AGENDA
Planning Board Meeting
July 28, 2026 - 6:30 PM
TOWN HALL (14704 N Old Statesville Road)

Consider a recommendation on Rezoning Petition #R26-07, a request by Bi-Part Development LLC to rezone +/- 5.262 acres located on Maple Branch Drive from Special Purpose - Conditional District to Special Purpose - Conditional District for commercial uses. This request is to amend the approved Rezoning #R24-04 to allow for two additional flex buildings on Parcel A with an ordinance modification.

Case Number/Project Name: R26-09 Town 1
Revision

REZONING PLAN

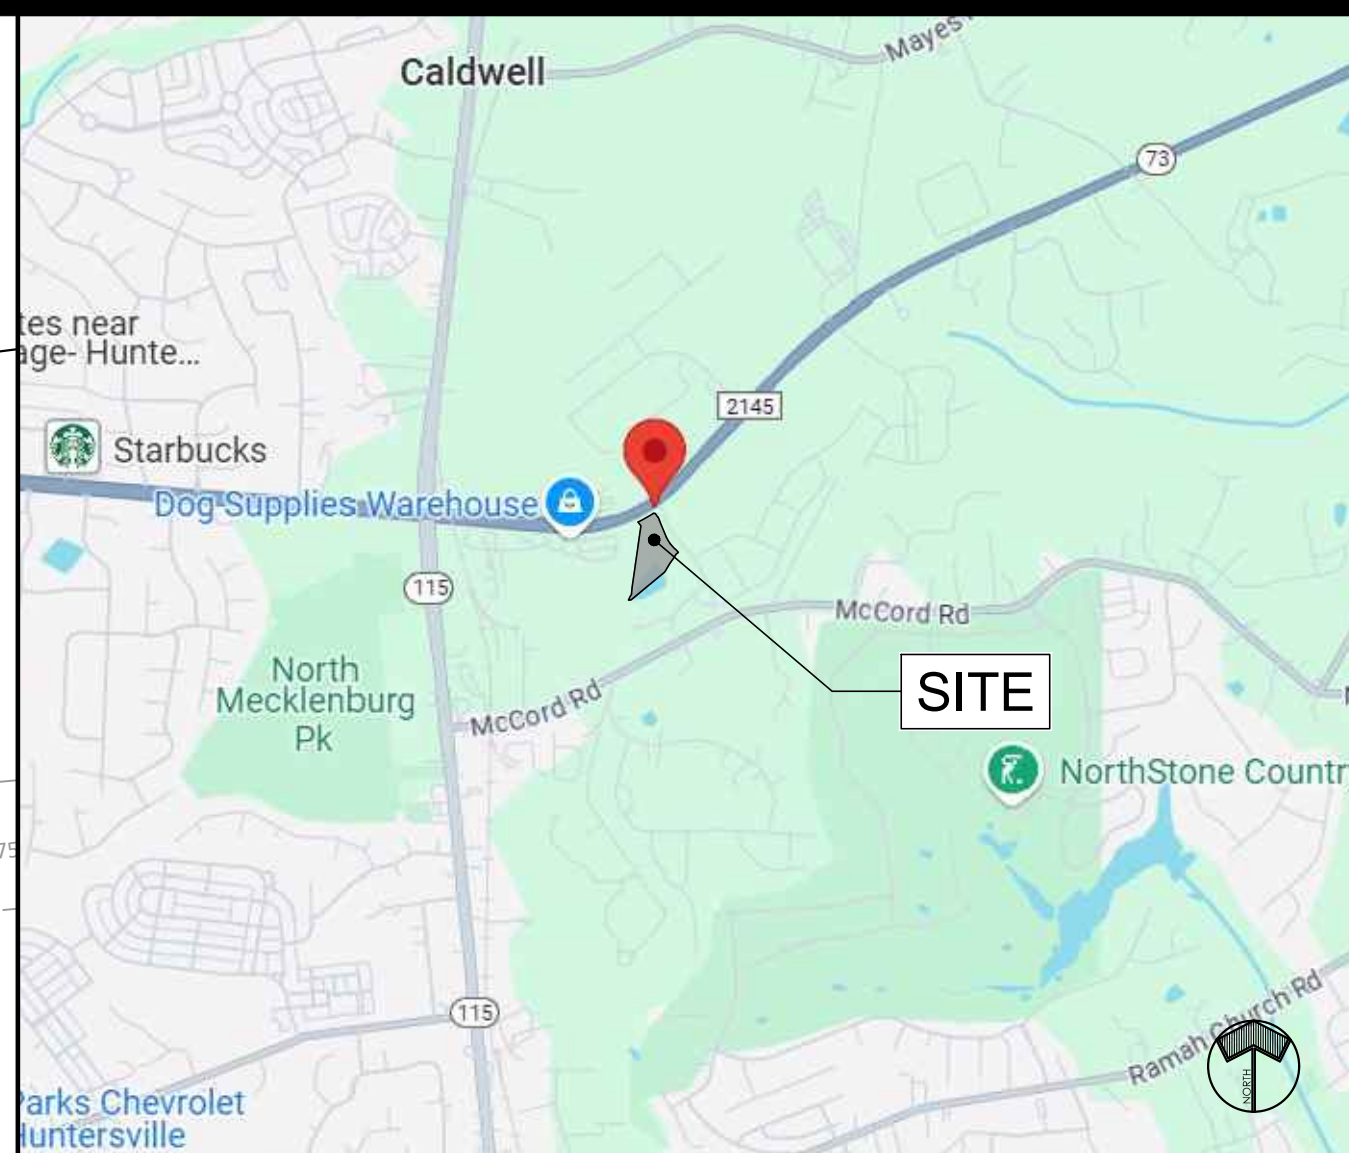
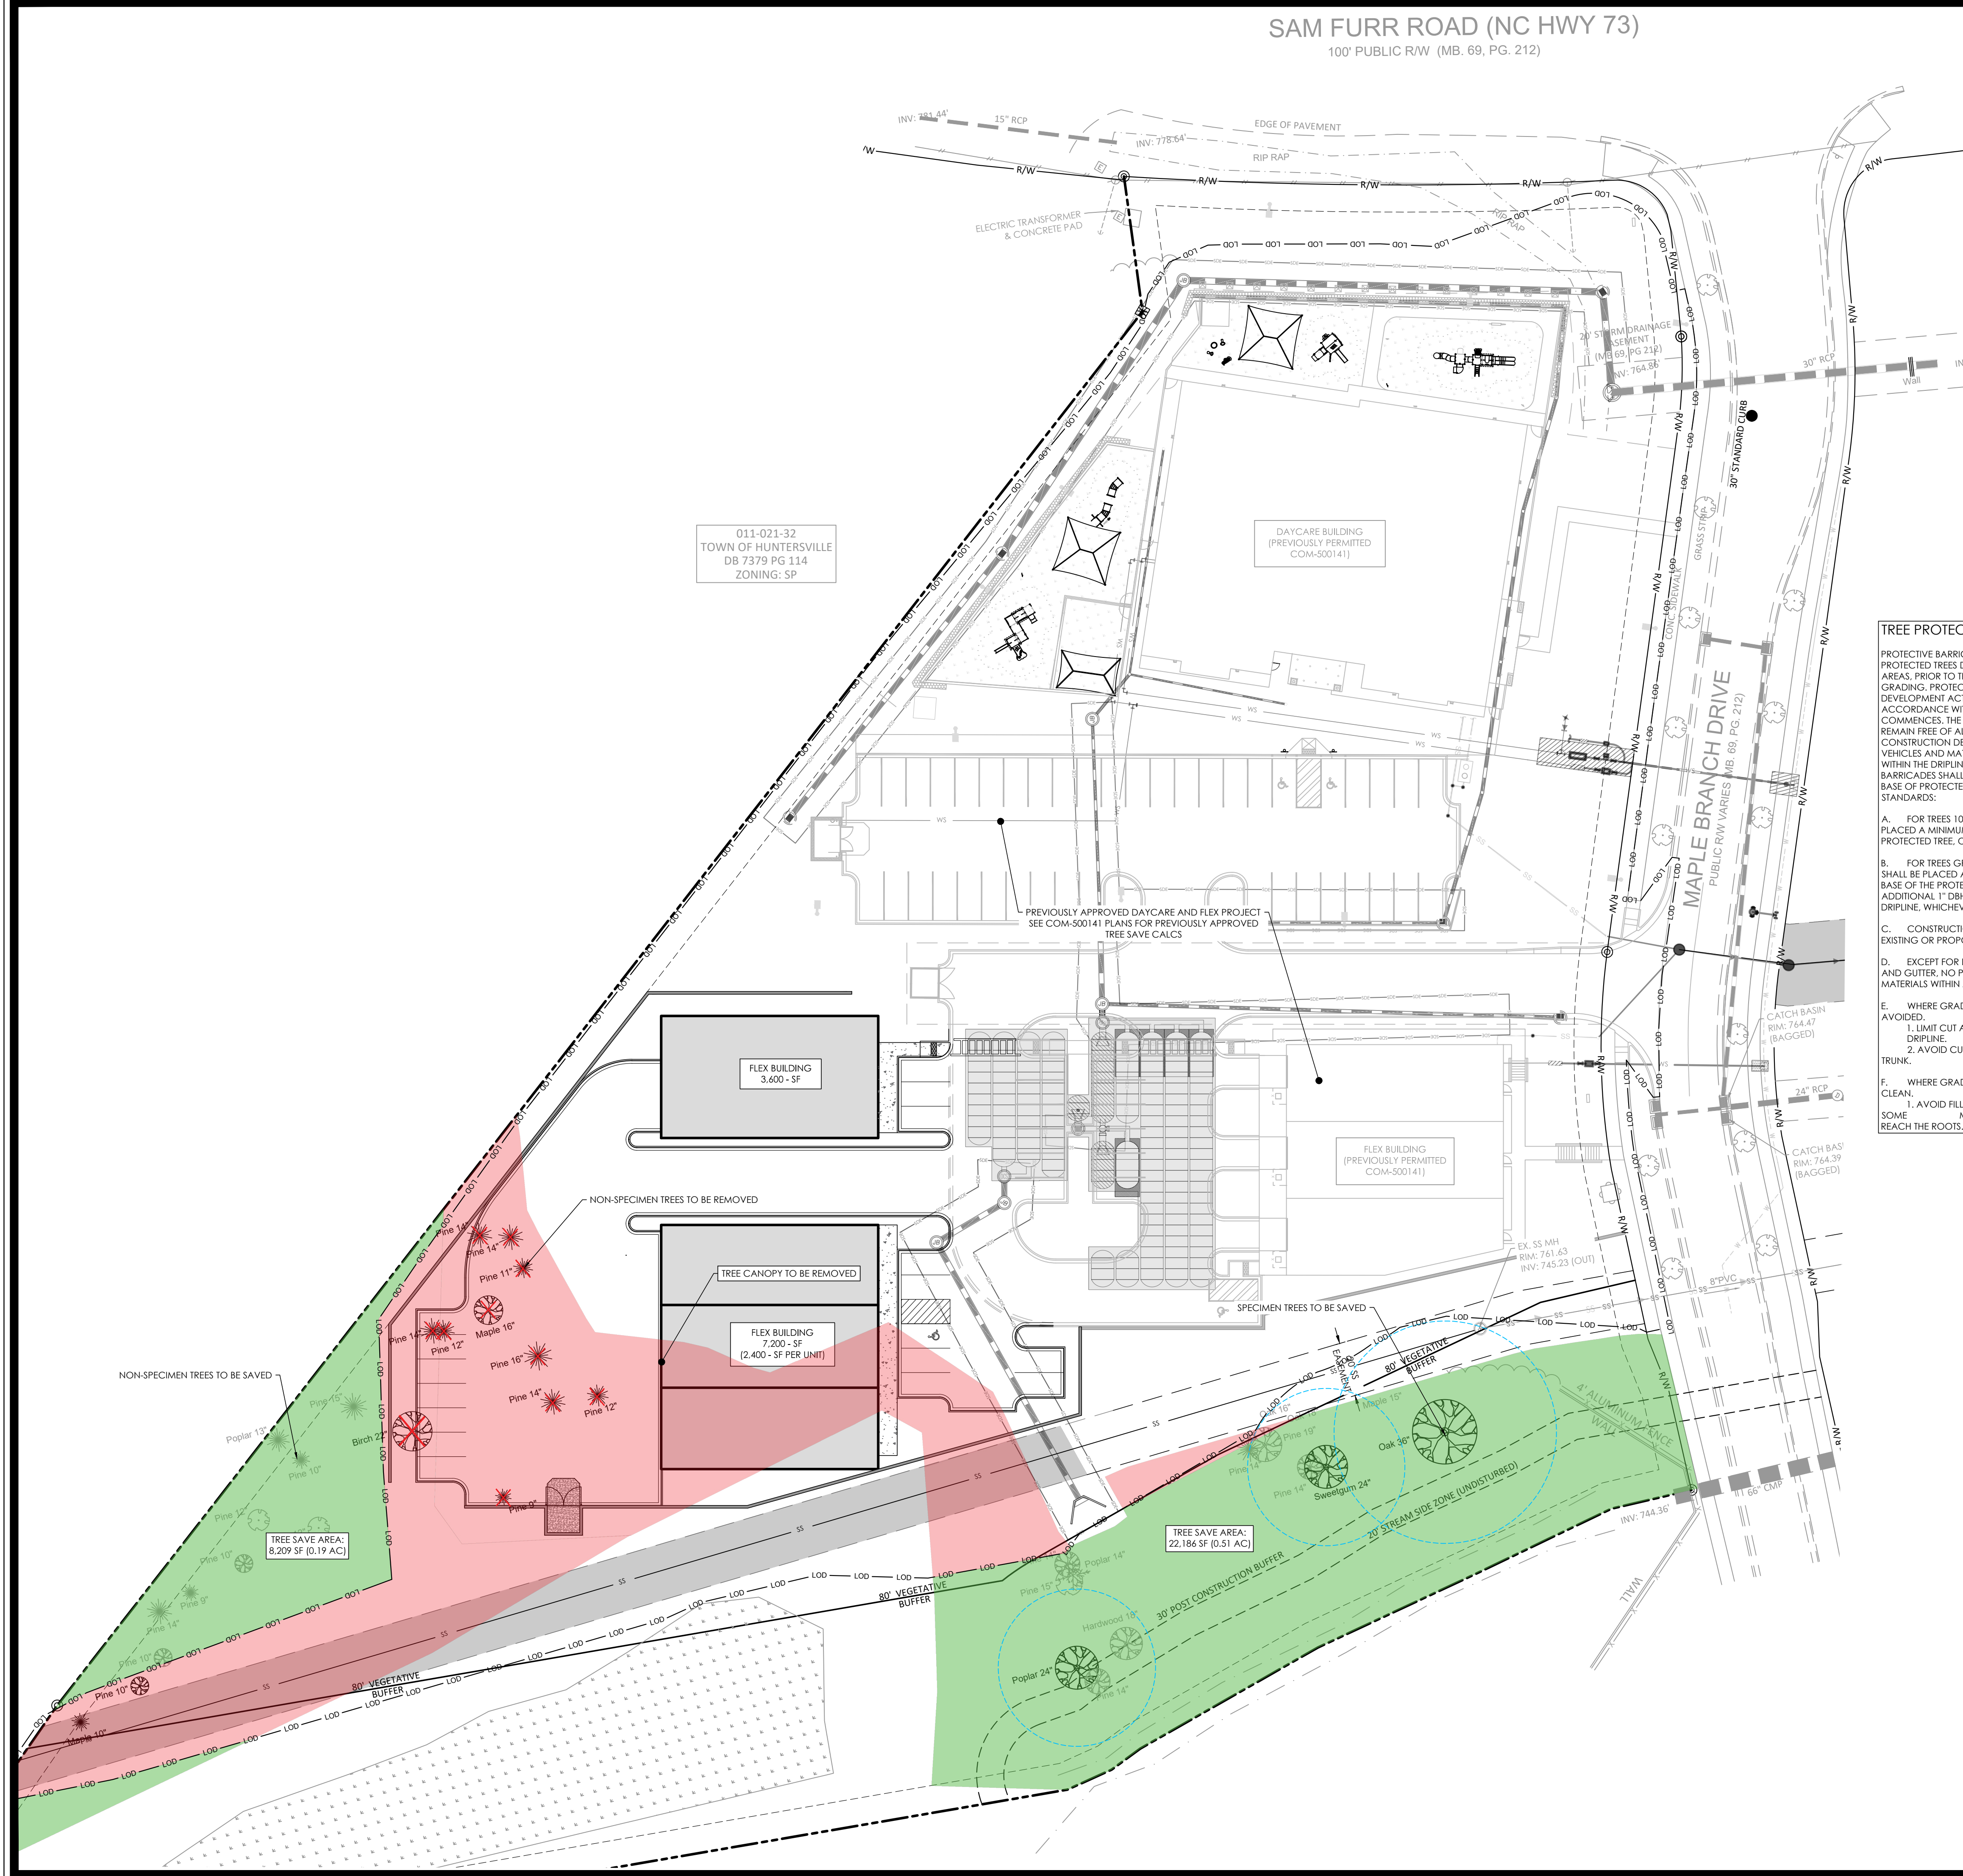
- Staff comments: Screening for the parking/loading areas on the back buildings are still needed. The applicant is requesting a modification.

Modification Request 1: *Relief from article 8.1 For street frontage requirements*

- Staff Comments: Since the lot still offers an 80-foot vegetated buffer, staff is ok with 2 small buildings not including Urban Open Space for frontage. It is appropriate in this situation with lot shape and size along with appropriate screening at the street level and adjacent to single family parcels with an 80-foot vegetated buffer.

Modification Request 2: *Relief from Article 6.1 Off Street Parking Design. Specifically Screening.*

- Staff comments: In considering the proposed rezoning amendment petition R26-07 Northbrook Flex, staff could support the rezoning revision with the following conditions:
 - A) The modification to allow the two buildings to the rear of the site is approved
 - B) The modification for relief of parking/loading screening is revised to show compliance with ordinance standards.
 - C) Any additional minor staff comments are revised prior to the final stamped plan approval.

TYPICAL SIDEYARD PARKING SCREENING - (N.T.S)

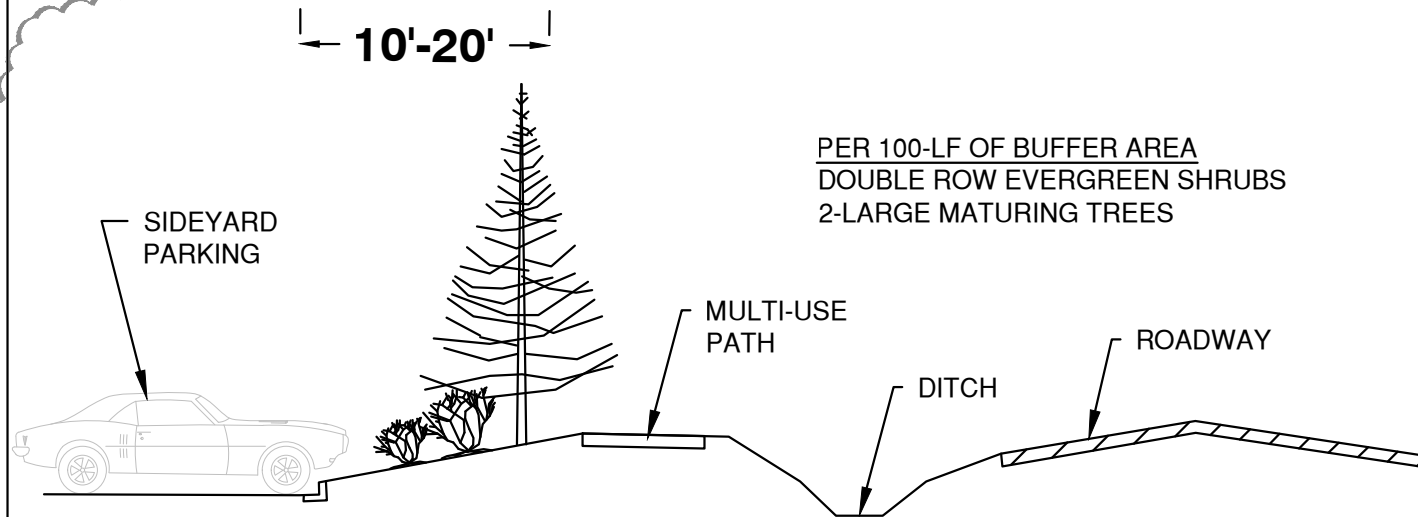
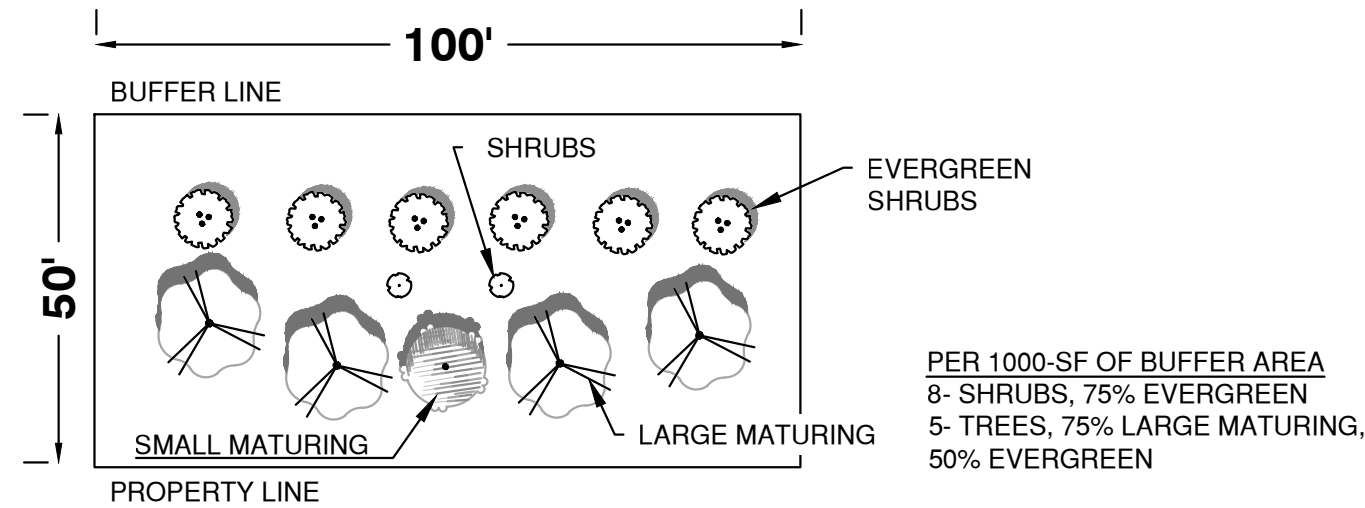
- MODIFICATIONS TO STANDARDS
PURSUANT TO SECTION 11.47(C) OF THE ORDINANCE, THE STANDARDS OF THE ORDINANCE ARE MODIFIED TO PERMIT THE FOLLOWING:
1. SIDEYARD PARKING IS PERMITTED ON LOTS #6, 7, 8, 13, 18 & 19. ADDITIONAL SCREENING SHALL BE PROVIDED IN ACCORDANCE WITH SHEET C9 OF THE REZONING PLAN.

TYPICAL 50' MITIGATED I-77 BUFFER -(N.T.S)

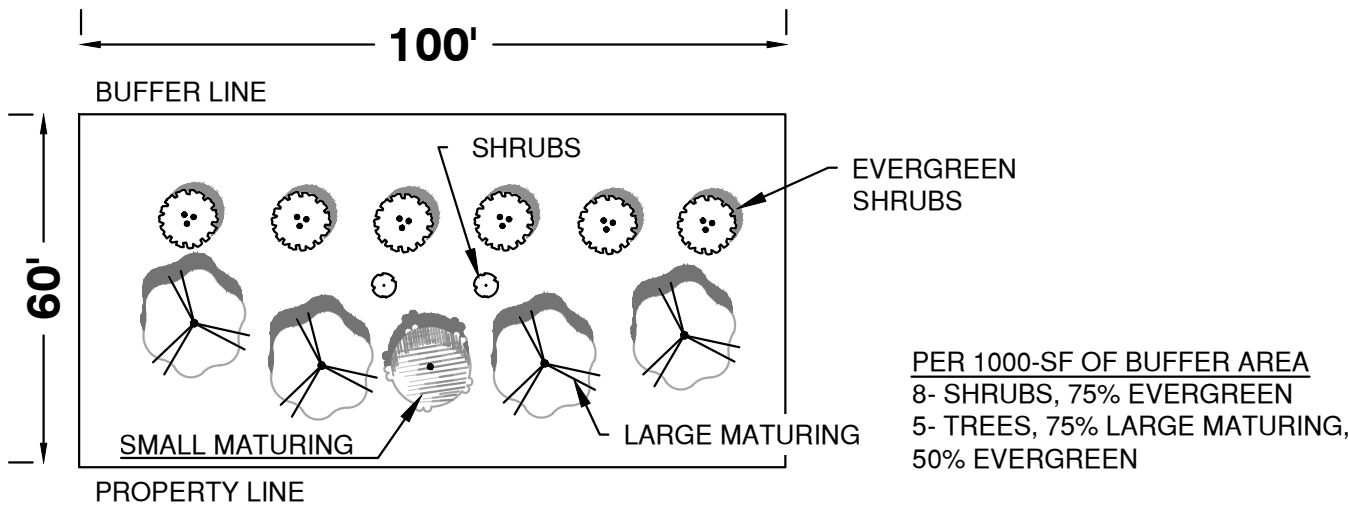
Modification Request: *I77 Buffer Impact Revision*

- Staff Comments: Staff could support this request with appropriately designed buffer mitigation and replanting.

2. BUFFER DISTURBANCE IN THE 177 BUFFER FOR GRADING (INCLUDING PORTION THAT APPEARS TO BE ALONG HAMBRIGHT RD.) SO LONG AS SUCH DISTURBANCE DOES NOT ENDOSE MORE THAN 20 FEET INTO THE BUFFER, PROVIDED AN ALTERNATE BUFFER YARD PLAN IS SUBMITTED IN ACCORDANCE WITH SECTION 7.5 OF THE ORDINANCE.
